# Delegated Report

## *Planning and Listed Building Consent Applications*

**Location:** 27 Shrubbery Road Gravesend Kent DA12 1JW

**Description:** 20250285 - Replacement of front boundary wall and railings with original style 'wrought' iron railings and gate.

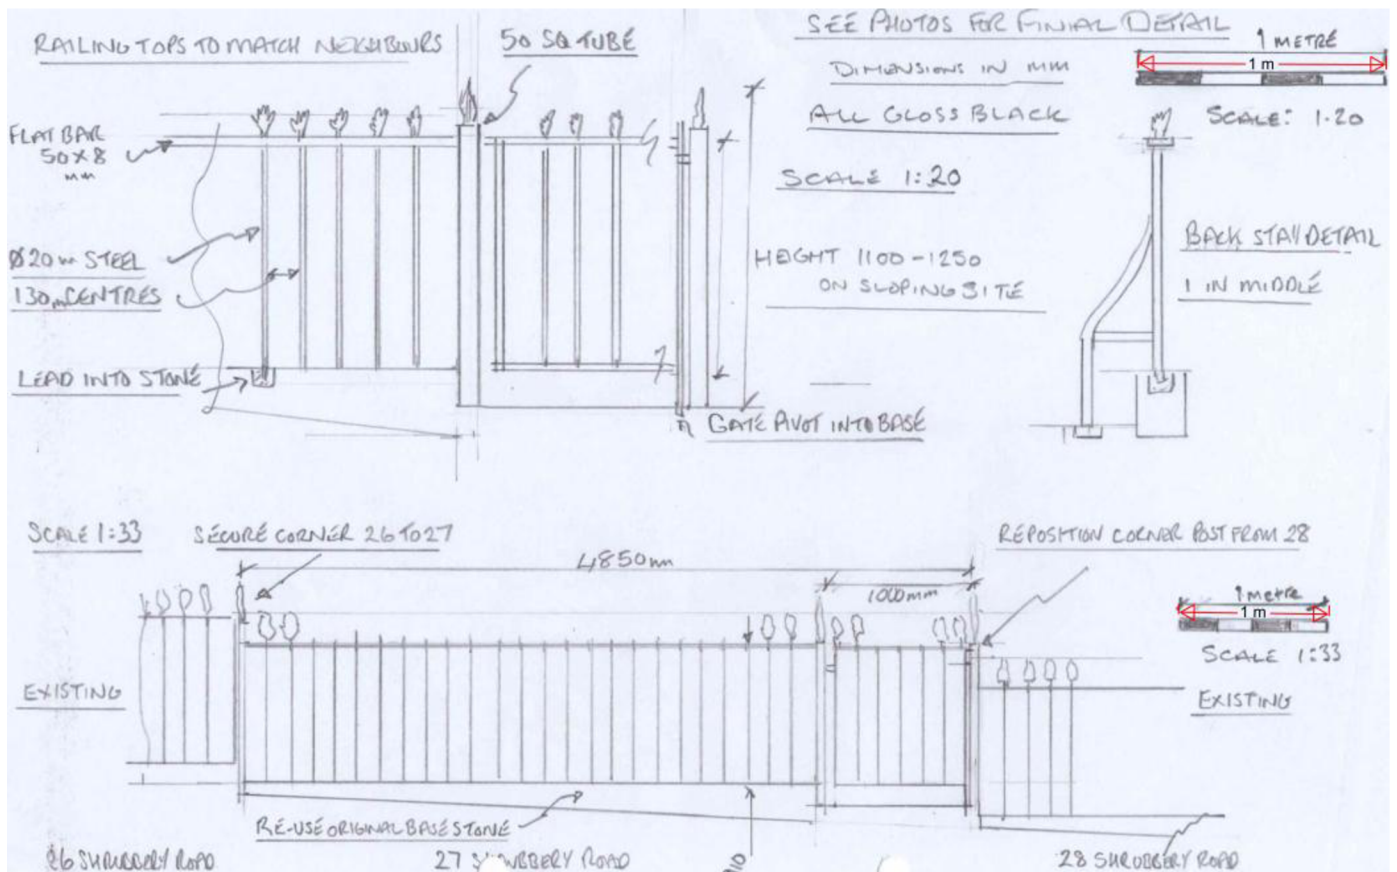
At some point in time the original front boundary wall and railings have been removed (this appears some time ago given the style of the existing wall and railings):

The removal of the current modern wall and railings is therefore welcome.

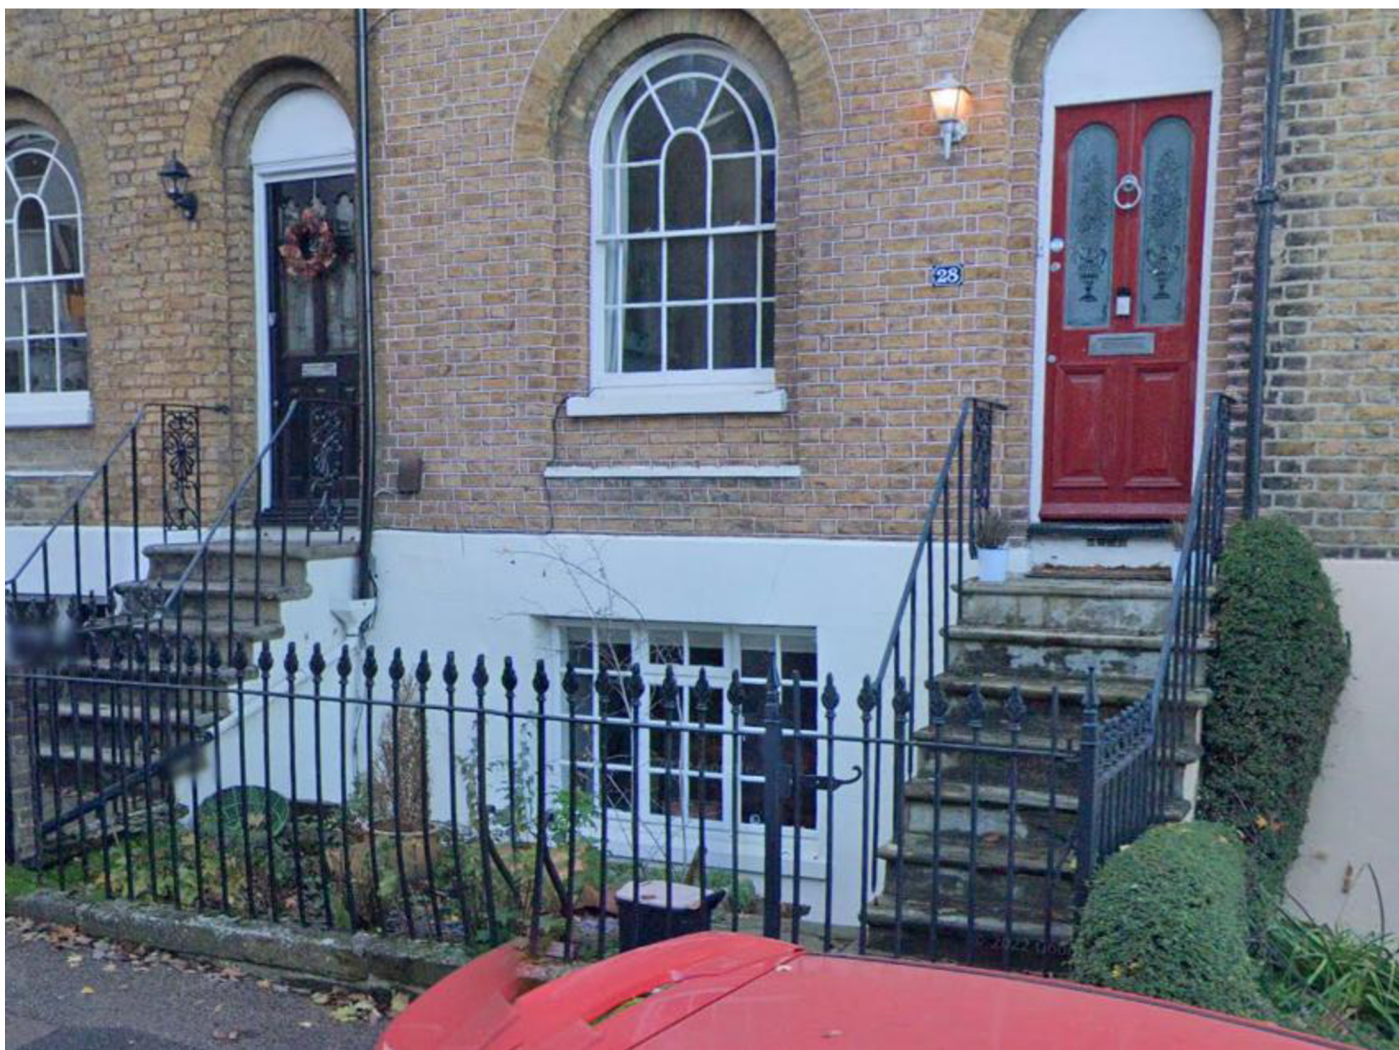
The proposed front boundary wall and railings are considered acceptable. They are of traditional design and materials with the railings to be individually set into the dwarf wall, backstays and the base stone under the existing wall will be re-used:
